# USB Power Delivery ENGINEERING CHANGE NOTICE

**Title: USB PD R3.0 V2.0 ECR Peak Current PD2 and PD3**

**Applied to: USB Power Delivery Specification Revision 3.0  
Version 2.0**

<b>Brief description of the functional changes proposed:</b>
There is not any functional change proposed. This is a clarification to the original intent for the power the New Sink can draw during the Implicit Contract following a PR_Swap.

Figure 7-28 Transition Diagram for a Sink Requested Power Role Swap

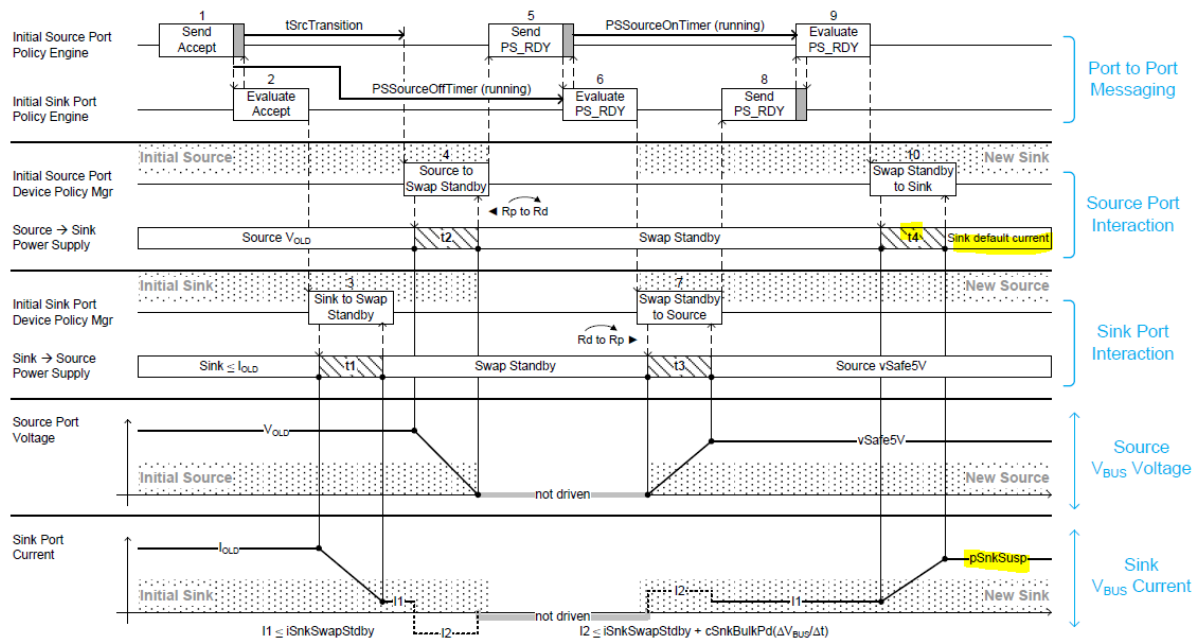
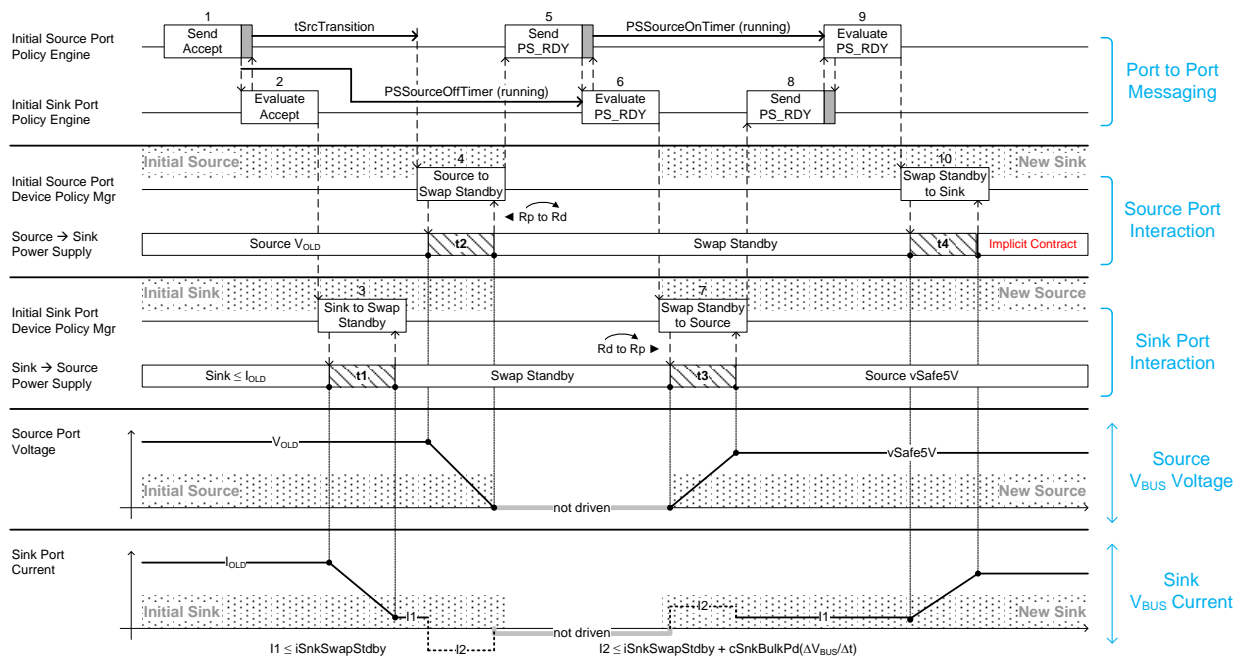
(a). Section 7.3.9, Figure 7-28, page 283

## (b). Section 7.3.9, Table 7-9, page 285

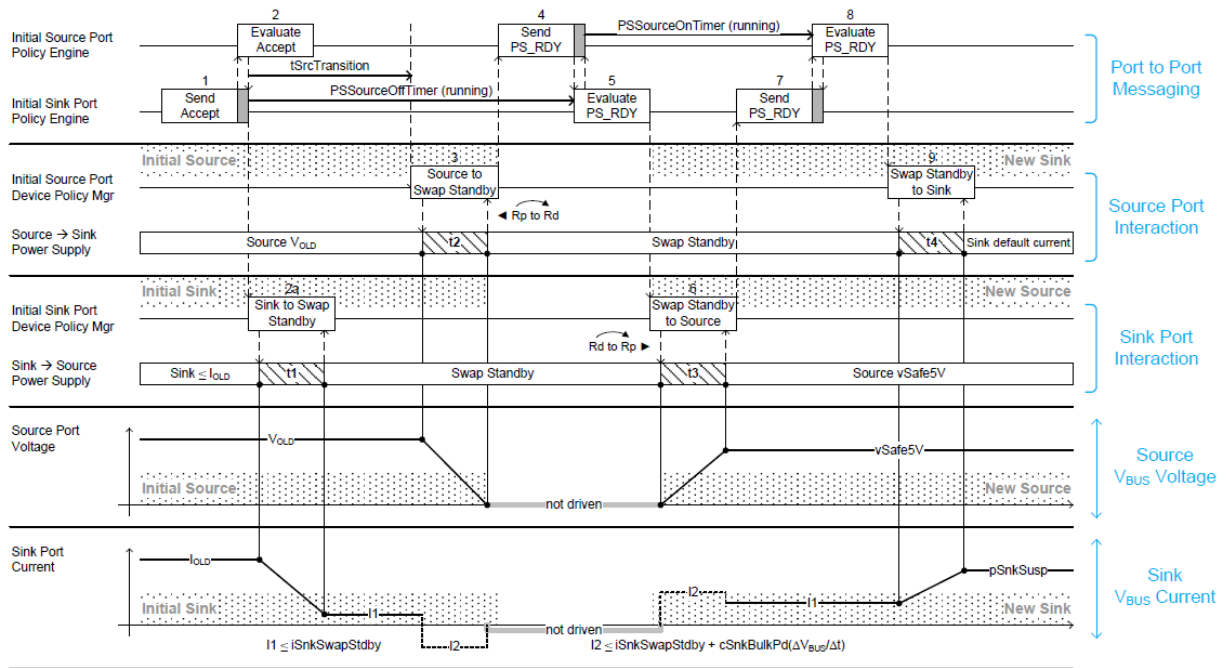
Step	Initial Source Port → New Sink Port	Initial Sink Port → New Source Port
10	The power supply as the new Sink transitions from Swap Standby to drawing <i>pSinkSusp</i> within <i>tNewSink</i> (t4). The power supply informs the Device Policy Manager that it is operating as the new Sink. At this point subsequent negotiations between the new Source and the new Sink <b>May</b> proceed as normal. The Sink <b>Shall Not</b> violate the transient load behavior defined in Section 7.2.6 while transitioning to and operating at the new power level. The time duration (t4) depends on the magnitude of the load change.

Step	Initial Source Port → New Sink Port	Initial Sink Port → New Source Port
10	The power supply as the new Sink transitions from Swap Standby to drawing <u>the current allowed by the Implicit Contract</u> <del><i>pSinkSusp</i></del> <u>within <i>tNewSink</i> (t4)</u> . The power supply informs the Device Policy Manager that it is operating as the new Sink. At this point subsequent negotiations between the new Source and the new Sink <b>May</b> proceed as normal. The Sink <b>Shall Not</b> violate the transient load behavior defined in Section 7.2.6 while transitioning to and operating at the new power level. The time duration (t4) depends on the magnitude of the load change <u>(see <i>iLoadStepRate</i>)</u> .
